Plan Commission

Agenda

Monday, April 25, 2016

Item 4: Review and Recommendation on the Site Plan Application for De Pere Café, located at 1104 Honey Court (ED-1469). Applicant: Alliance Construction & Design

Figure 4: Potential Site Plan Improvements

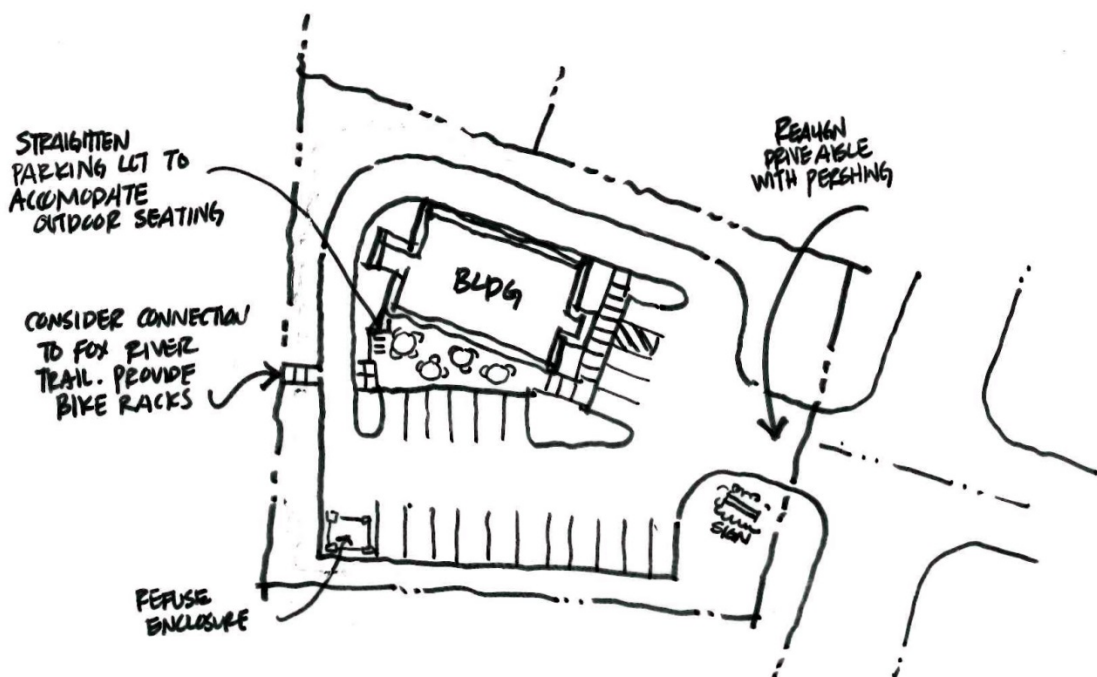
The below comments are recommendations in order to approve the functionality and aesthetic of the site plan and building, but are not required by City Ordinance. These suggestions are illustrated in the below sketch.

1. Consider realigning the parking lot to provide a consistent 24' drive aisle. This reduces the amount of pavement in the parking lot and also provides an open area for an outdoor café on the south side of the building.
2. Improve pedestrian and bicycle access by providing a connection to the Fox River trail and bike racks.
3. Consider shifting the parking lot entrance slightly to the south so that it aligns with Pershing Road.

SHEET: C10

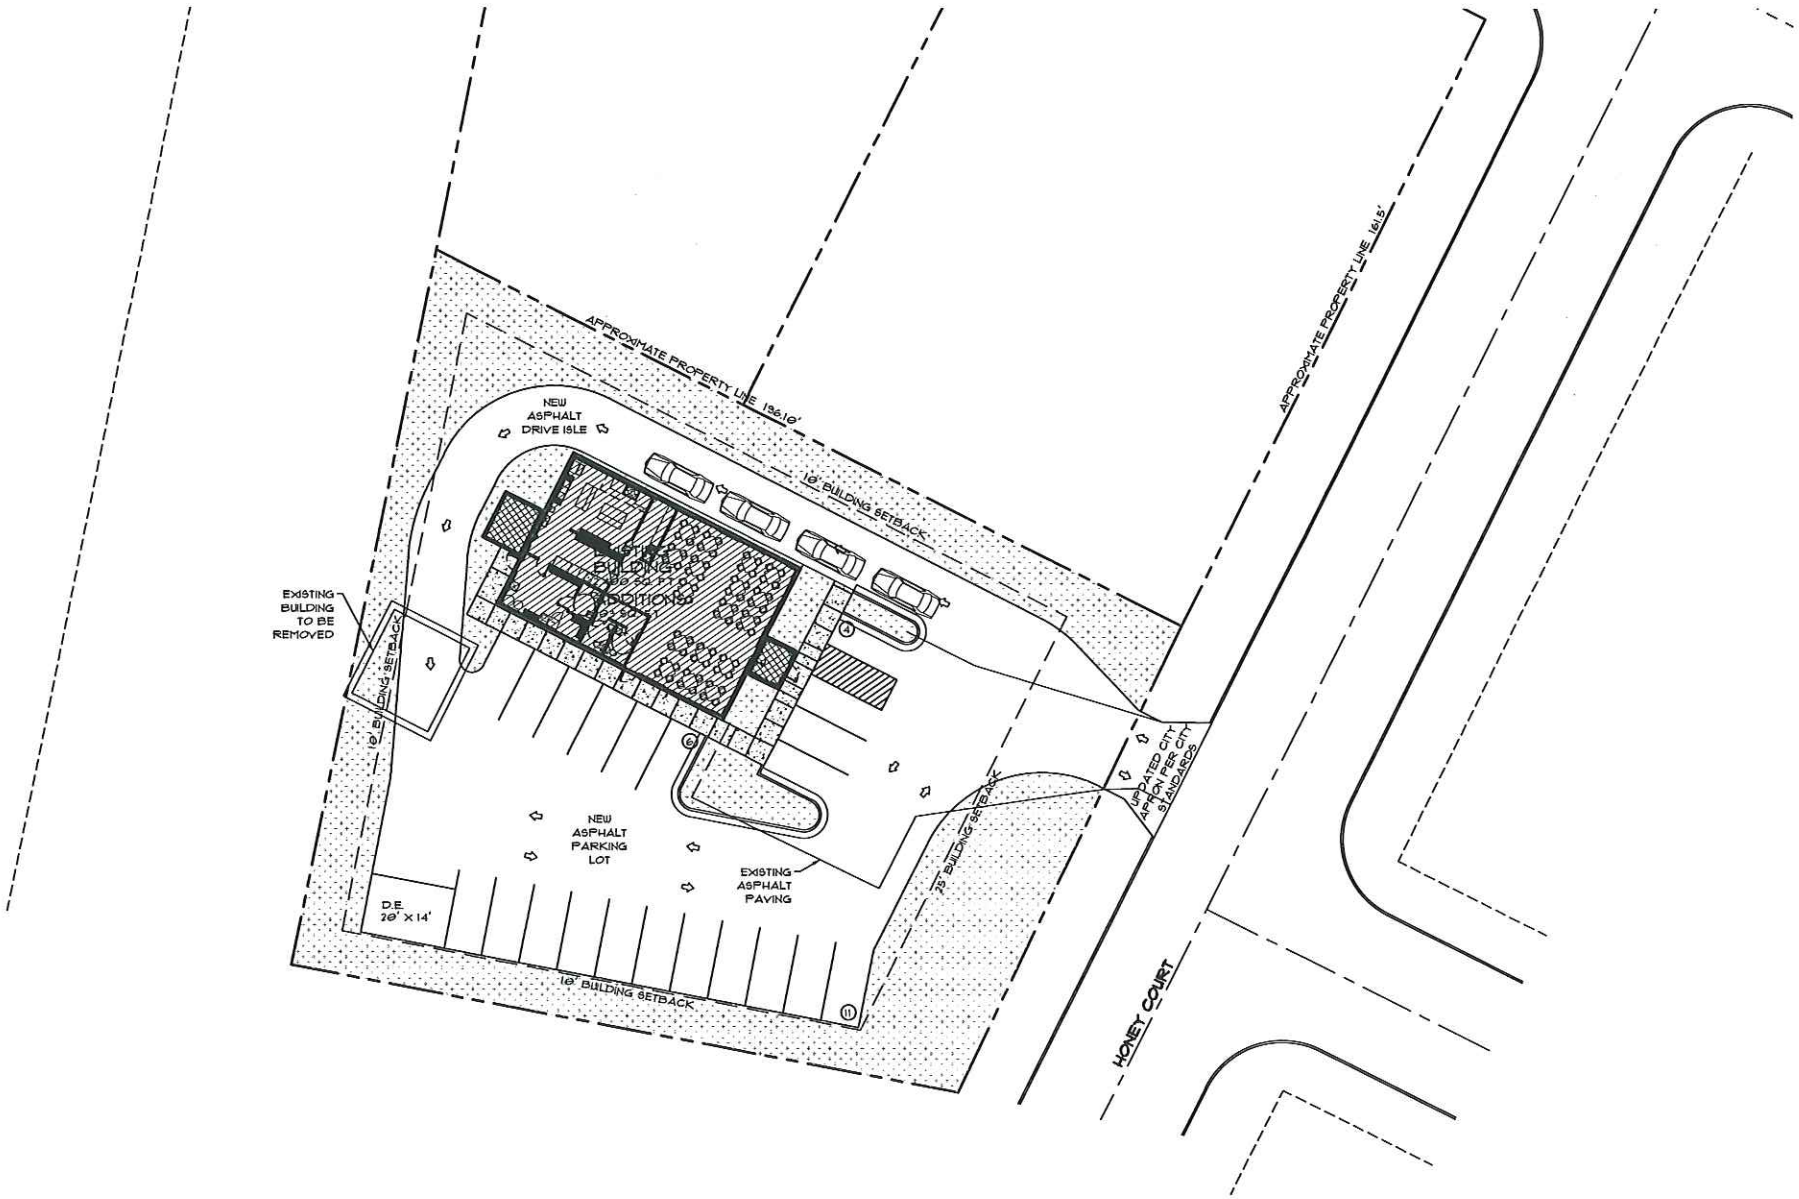
1. Provide address of the owner on the plan.
2. Provide north point indicator on the plan.
3. Show existing gas, electric, sanitary sewer, storm sewer, or other utilities on the plan. No new sanitary or water main connections are proposed for the site.

6. CSM records indicate a 6 foot utility easement along the north and east property line of this parcel. Show this on the plan.
7. Show dimensions of adjacent streets and right of ways on the plan.

8. A curb cut permit is required if the new driveway width will be changed or relocated. Show the dimensions of the driveway at the curb line and at the property line on the plan. The City standard requires a concrete driveway and a sidewalk section through the driveway.

9. A storm water management plan is required if land disturbance is 20,000 SQ. FT. or more or 1 acre of impervious surface is constructed.
10. Show the existing sign on the plan and specify if it is removed or will remain.
11. Provide topographic contours (two foot minimum).
12. All off-street parking shall have a perimeter concrete curb and gutter around the entire parking lot unless the site plan shows that runoff from the parking lot will not cause erosion or adversely affect adjacent properties.
13. Show dimensions of proposed parking spaces and label the handicap parking spaces on the plan. Provide the proper signage. Striping needs to be a minimum of 4" wide paint.
14. A landscape plan was not included with the application and must be submitted for review.

102 N. Broadway
Approved North Elevation – September 2015

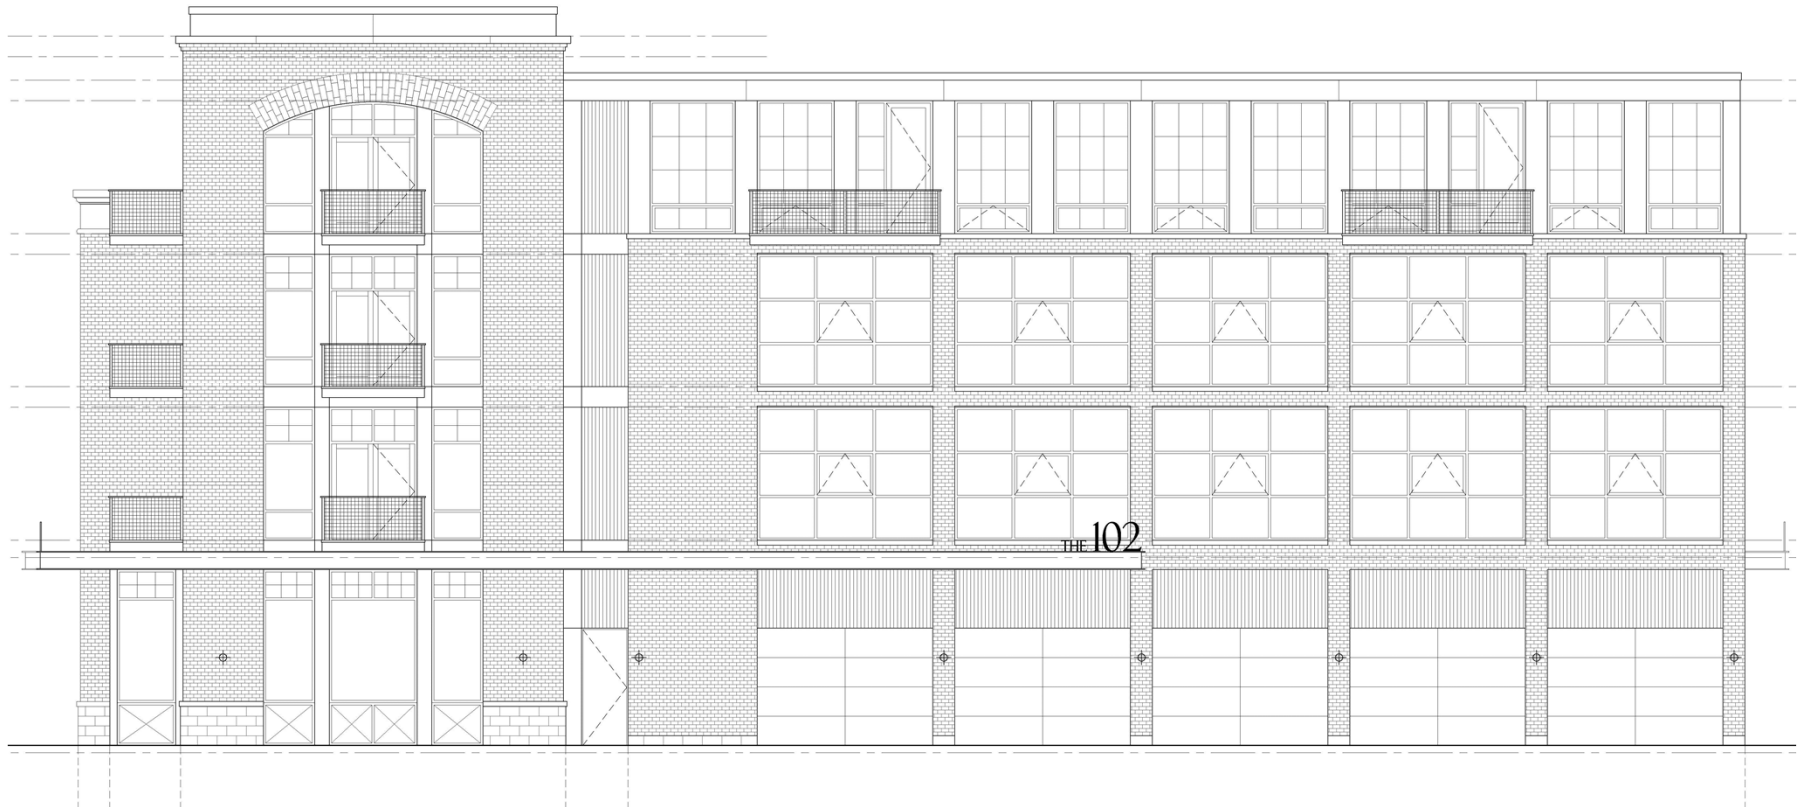
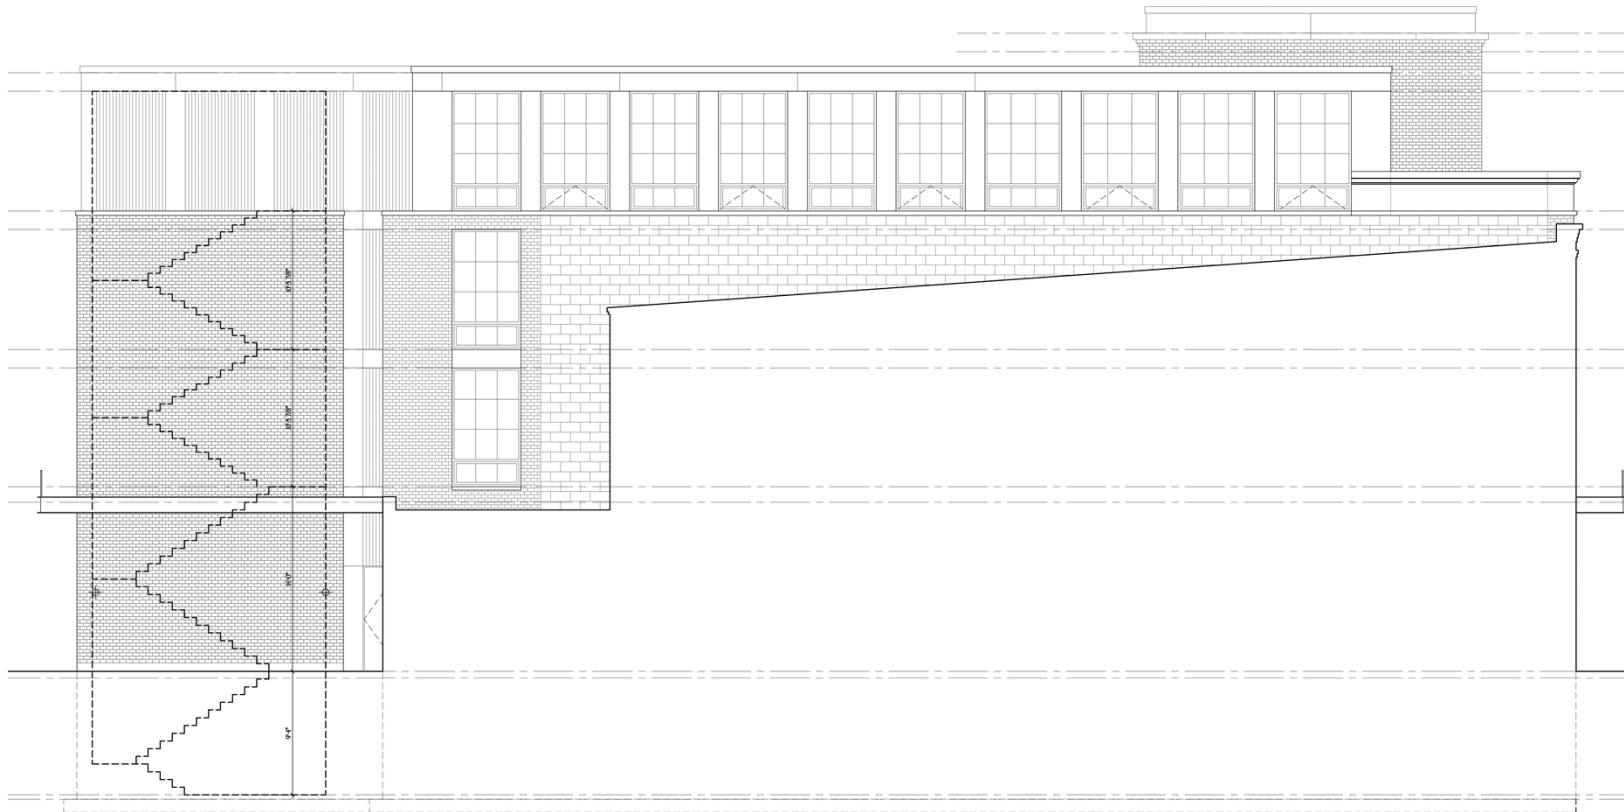
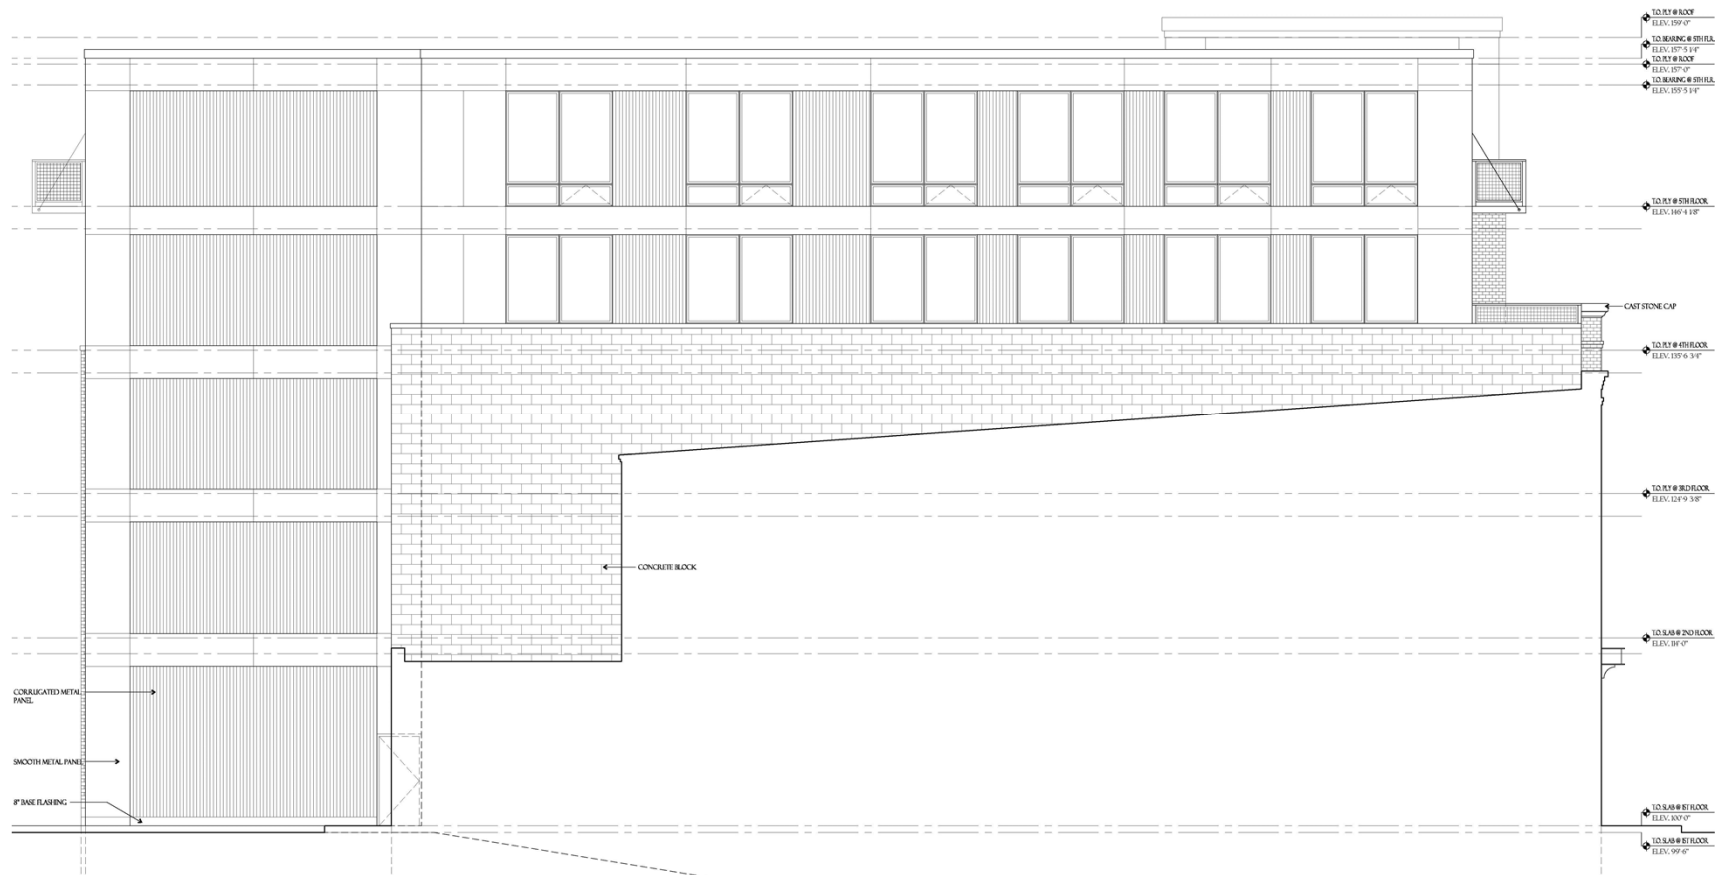
Due to the construction type, final layout of the units, and project scope increase, changes to the architectural design of the building are proposed. Some of the changes are considered minor and are typical as projects move from schematic design into permit drawings. Other changes have been proposed in response to the additional height and construction type. A summary of the changes is provided below and a visual comparison between the approved elevations and the proposed changes is provided on the attached appendix.

- Additional story has been added. The façade of the top floor proposed to be clad in decorative metal panel. Masonry is not an option on the top floor due the restrictions of the construction type.
- Due to the height restrictions of the construction type, the curved masonry accent arches have been removed.
- The color scheme has been updated from a cream city brick to a richer palette of reds, limestones and bronzes.
- Balcony design and location has been refined to reflect the interior layout of the units. Juliet style balconies are proposed for floors 2-3 and larger balconies are proposed for the top floor. The third floor northwest corner units also have access to a terrace.

- Juliet style balconies have been added to a number of the units.
- The window design, particularly the shape and number of panes, has been updated to accommodate the patio doors and provide more open views from the residences. Transom windows, like those shown on the Broadway Street side, have been included to provide visual interest on the street facing façade.
- Due to the height restrictions of the construction type, the curved masonry accent arch at the southwest corner has been removed.
- The three columns framing the southern window bays previously included a staggered masonry striping detail. This detail has shifted to the first floor of the façade.
- The color scheme has been updated from a cream city brick to a richer palette of reds, limestones and bronzes.

- The window design, particularly the shape and number of panes, has been updated to accommodate the patio doors and provide more open views from the residences. Transoms have been added to the lower portions of the windows to provide visual interest and fit with the building character.
- A portion of the building near the northern garage entry was previously shown as brick on the first through third floors. This area is now shown as metal panel.
